**CONFIRMATORY SURVEY ACTIVITIES  
FOR THE  
FORT ST. VRAIN NUCLEAR STATION  
PUBLIC SERVICE COMPANY OF COLORADO  
PLATTEVILLE, COLORADO**

Fort St. Vrain Nuclear Station - March 21, 1996

At the request of the NRC's Division of Waste Management, the Environmental Survey and Site Assessment Program (ESSAP) of the Oak Ridge Institute for Science and Education (ORISE) performed independent confirmatory surveys activities at the Fort St. Vrain site in Platteville, Colorado. During the period January 22 through 25, 1996, ESSAP performed instrument comparison activities—including side-by-side surface activity measurements and surface scans—and reviews of the licensee's embedded piping program and planned use of *in situ* gamma spectrometry for determining the licensed material contribution to exposure rate.

FIGURE 5: Reactor Building, Level 3, East, 1B/ID Cooling Water HTX Room, Survey Unit F045

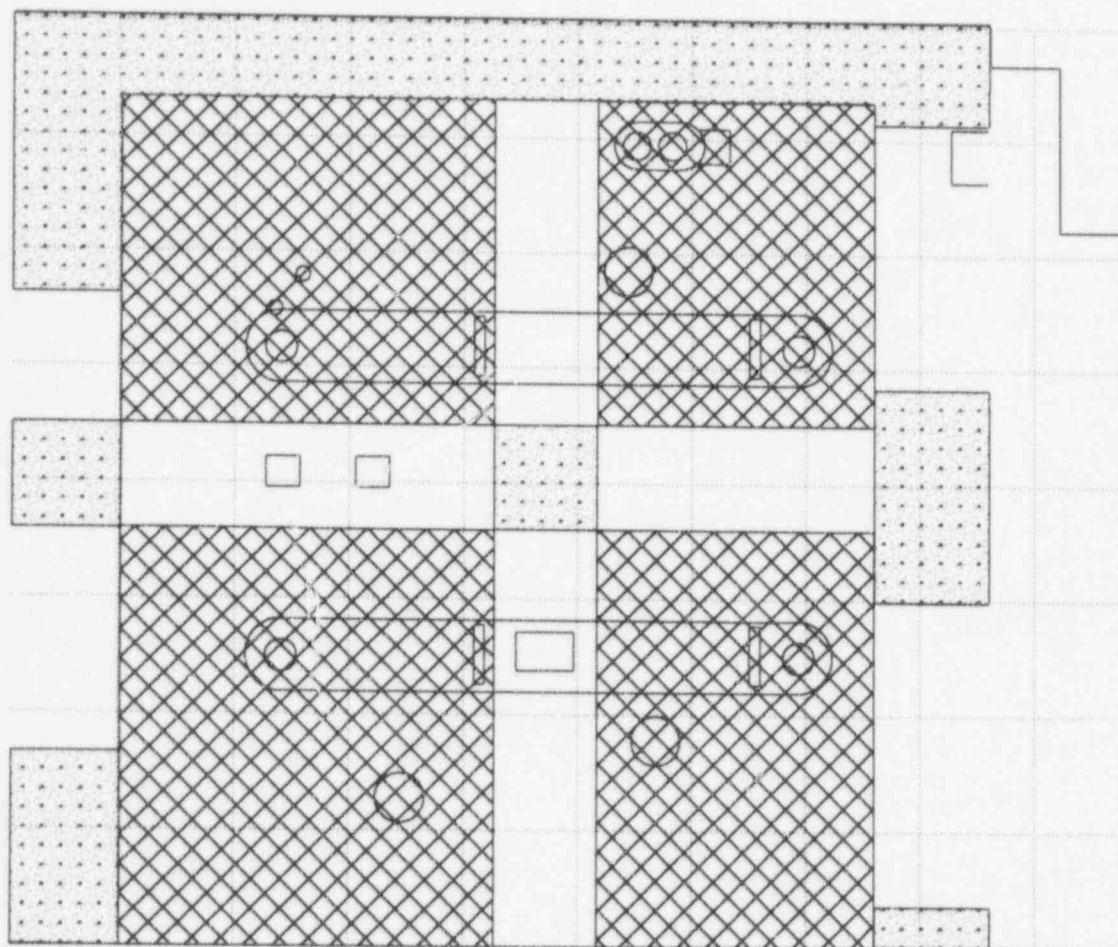
Survey unit F045, adjacent to F044, is also an affected area with a floor area of 214 m<sup>2</sup>. Due to the presence of plants systems, approximately 40% of the floor area was accessible to scans. No scans of the lower walls were completed. No areas elevated direct radiation were detected on the concrete and steel grate floor. The scan range was 1800 to 2600 cpm. As with F044, the licensee had not completed this survey package and comparisons to licensee data were not appropriate.
